OPTIONAL SERVICE BULLETIN

Model DA 40

OPTIONAL SERVICE BULLETIN NO. OSB 40-099 REV. 2 SUPERSEDES OSB 40-099 REV. 1

Replacement of EGT thermocouple assembly with alternate thermocouple assembly.

Figure 1. EGT probe (Thermocouple)

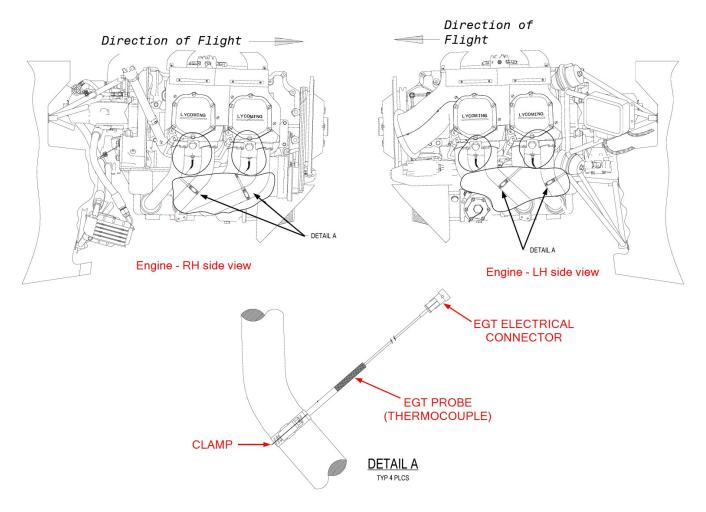
- 4. Disconnect the electrical connector from the EGT probe that needs replacement. Refer to Figure 1.
- 5. Release the clamp that holds the EGT probe in position. Refer to Figure 1.

- 6. Remove the EGT probe from the aircraft.
- 7. Put the new EGT thermocouple assembly (item 1) in position and tighten the clamp.
- 8. Connect the thermocouple adapter harness (item 2) to the new EGT thermocouple assembly (item 1) electrical connector and the engine harness thermocouple connection.
